SUBJECT: Exception request, PLM Subdivision

PROJECT PLM Subdivision Phase 2C

Design Exception 3-8-2010  
 Water Service in Public Sewer Easement

**RE: Item on 3/30/10 PW Committee Meeting: Design Exception Appeal; Water Service  
PLM Subdivision Phase 2C**  
CC: PLM Development

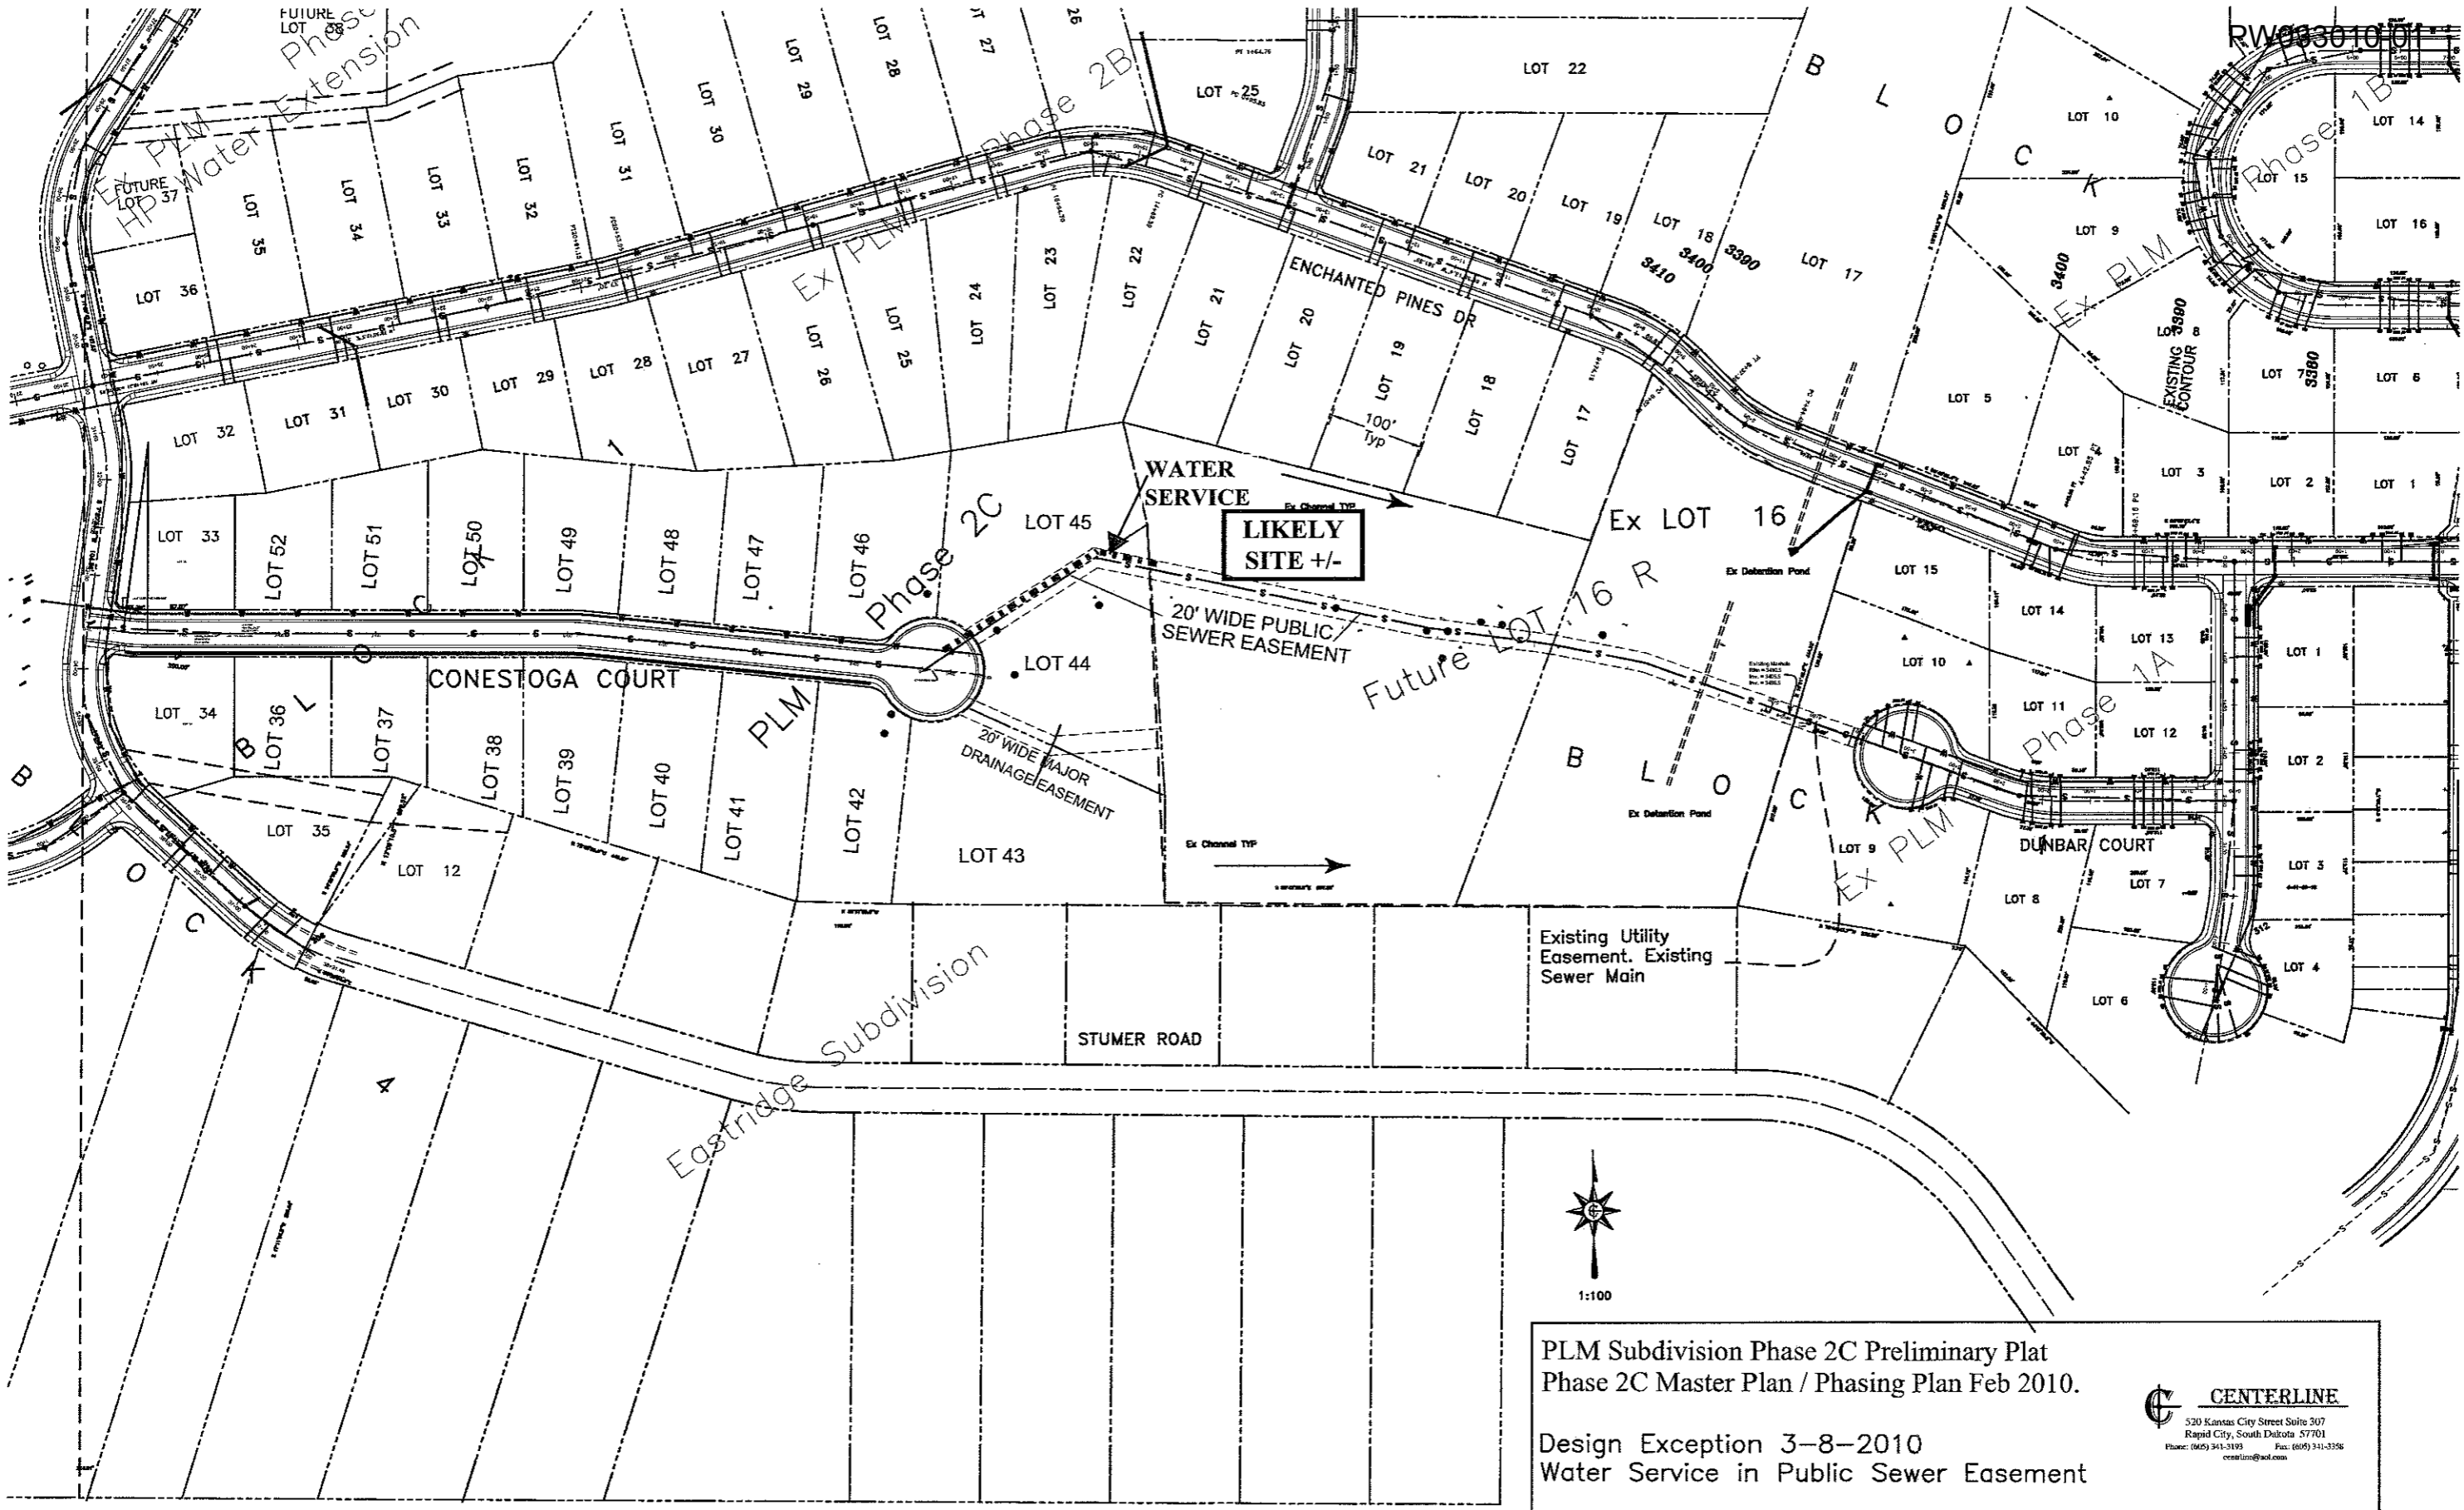
I have reviewed the exception request to allow a non conforming water service line across two proposed lots.

The information submitted by Centerline shows a proposed water service line to be extended in an existing 20' wide public sewer easement that is located on two proposed lots that adjoin the lot for which the service line is intended.

It is my opinion that the existing public sewer easement is not intended for a water service line and the installation of a service line within this easement may cause maintenance problems with the existing sewer main located within the easement. There are no extraordinary circumstances that exist that would support the installation of a non conforming water service line in this location. To preserve the ability to provide maintenance for the sewer main, the water service line should be located within its own easement if this exception request is approved by City Council.

Therefore, I recommend denial of the requested exception.

PLM Subdivision Phase 2C Preliminary Plat  
 Phase 2D Master Plan / Phasing Plan  
 Jan 2010  
 Mar. 24, 2010 Water Service Exception REVISION

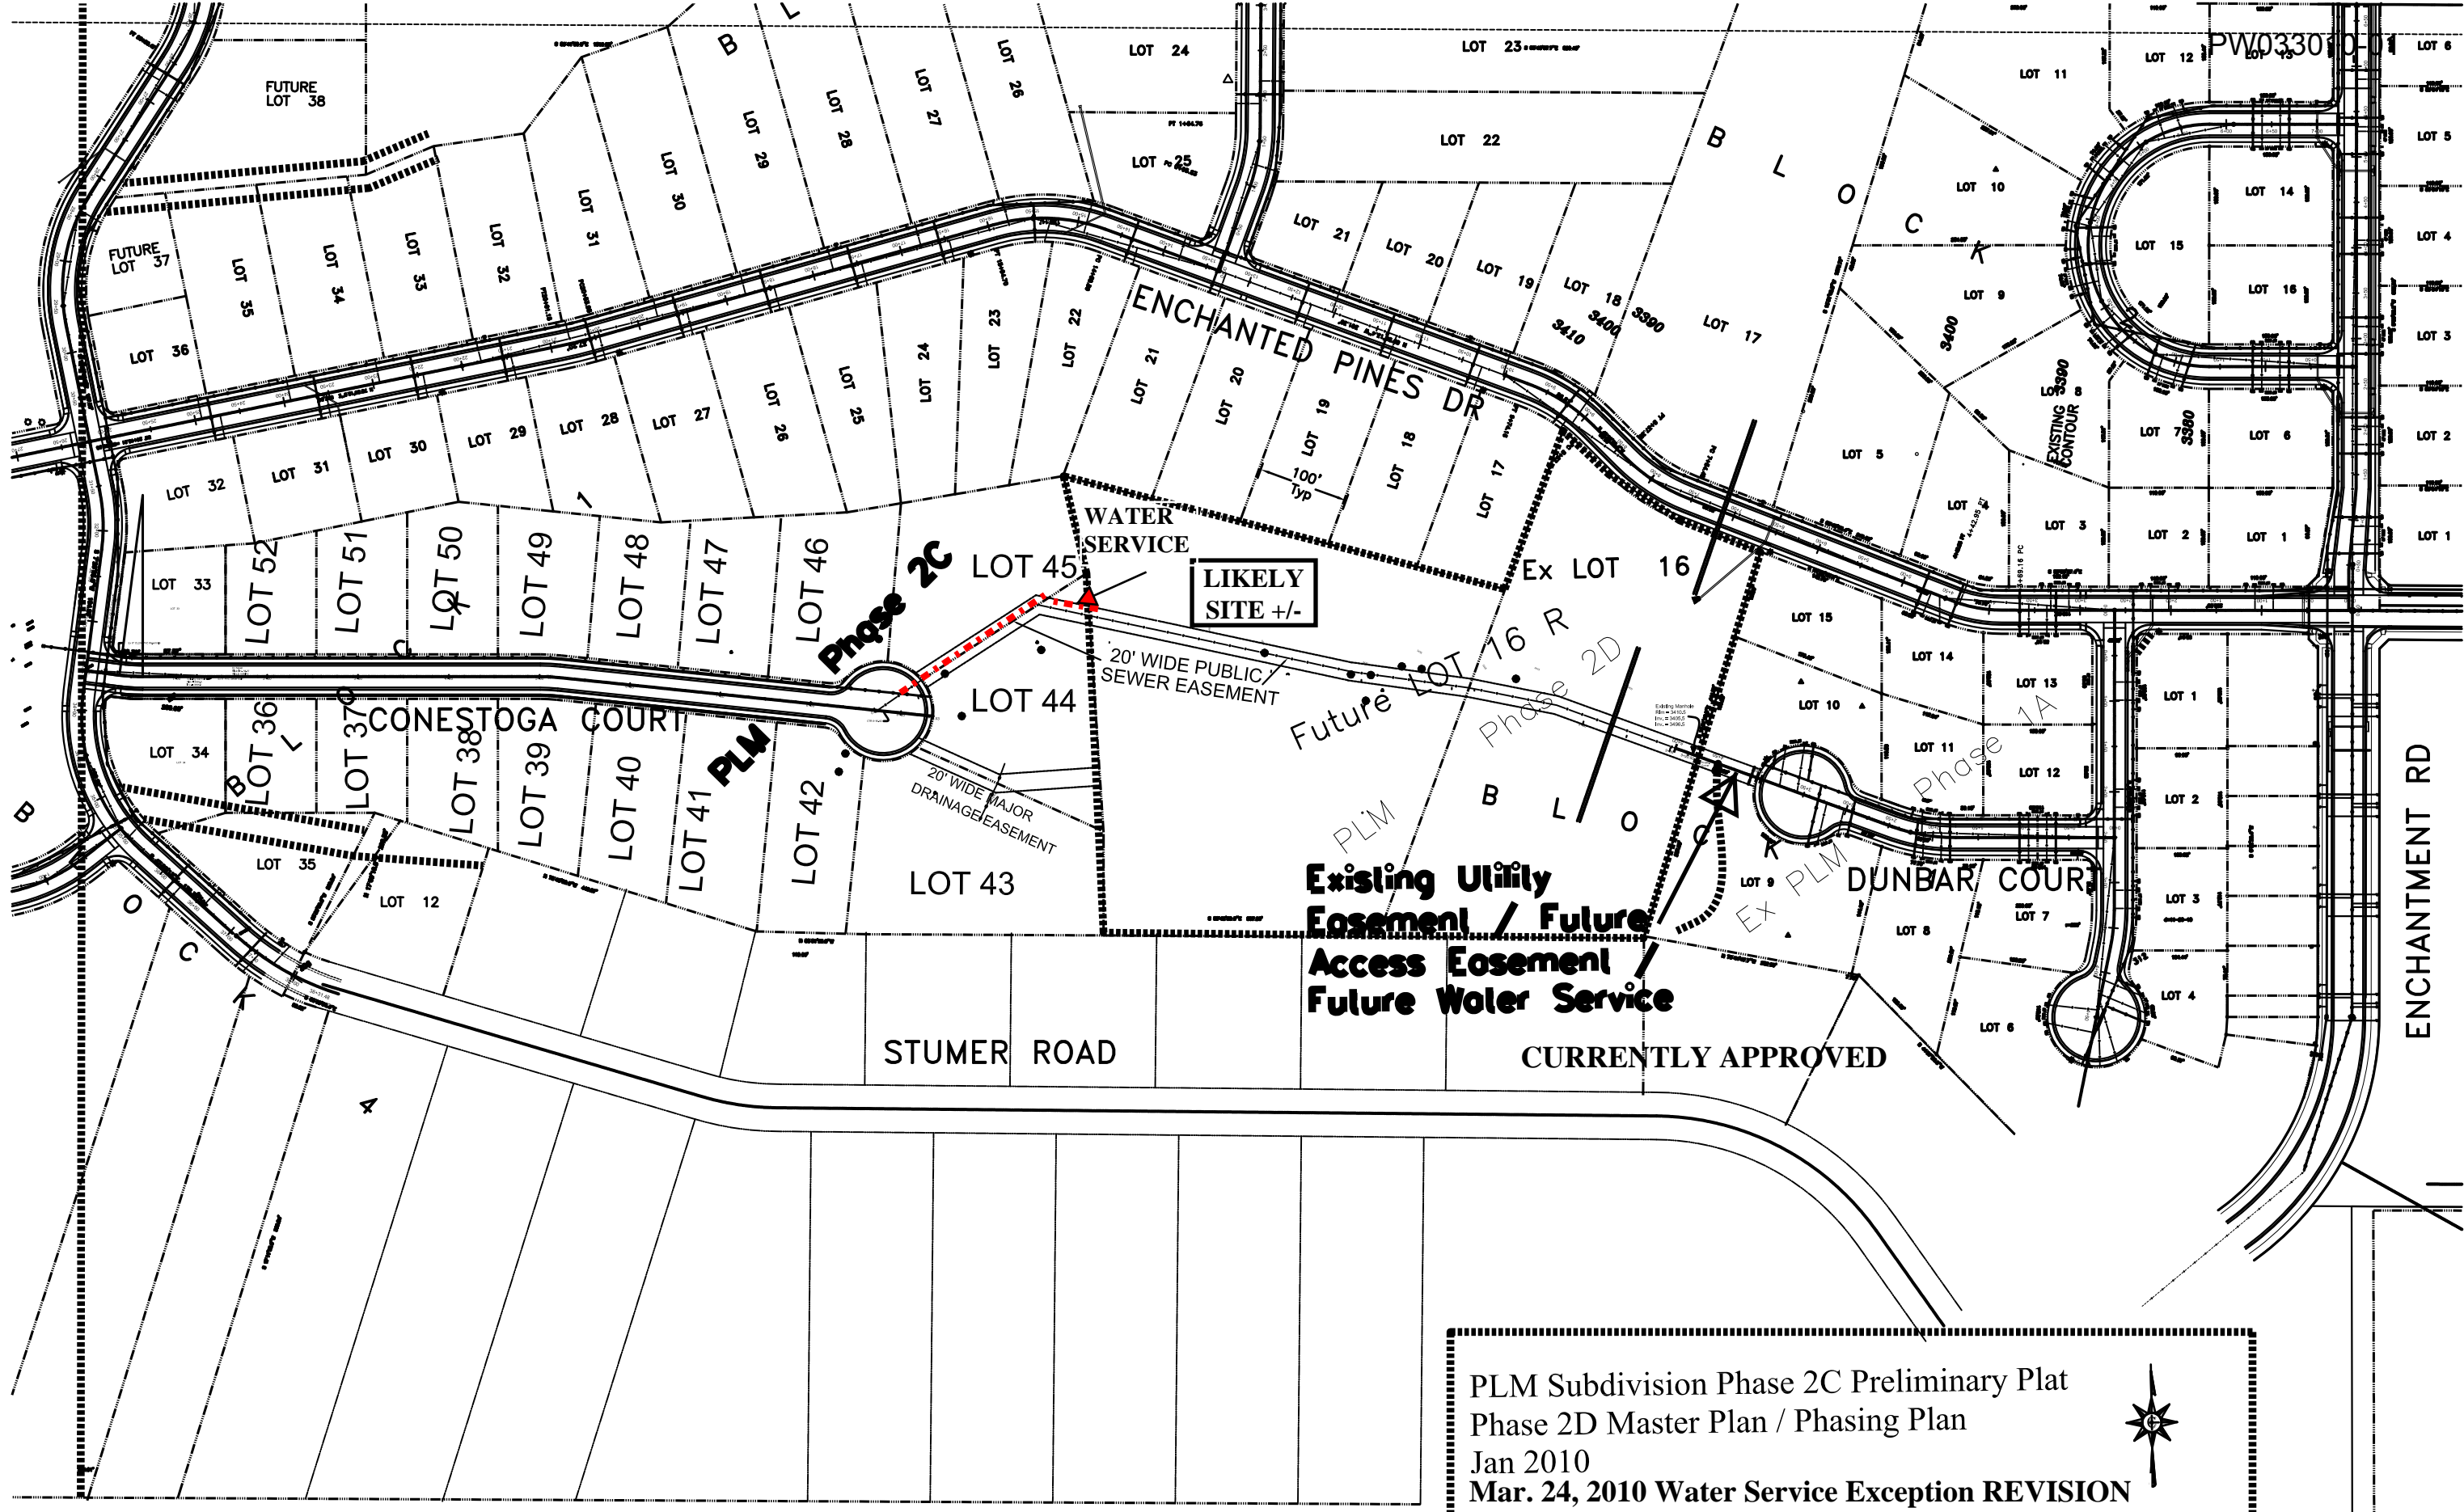
This request is nearly identical to the previously approved design exception for a water service in a sewer easement, except now at the west end.

After discussion with PLM Development, it became obvious that the most likely location for a home is at the west end of future 16R. Therefore, it was necessary to access a water pressure zone that would provide adequate pressure. The pressure zone serving Conestoga Court is correct for this proposed home site.

Placement is essentially no different from the previous request: ie., within the same easement provided for the sewer main. Also, Ten States Standards – the document that provides guidance for water systems – allows for benching water above sewer when horizontal distance is difficult to achieve.

In this instance the terrain constraints are as difficult as the east end, but will allow for a comfortable corridor following 10 States guidelines and encasing where necessary. The attached drawing illustrates the strategy.

PLM Development, LLC asks that you approve the placement of a water service line in the proposed easement in lieu of the previously approved exception.
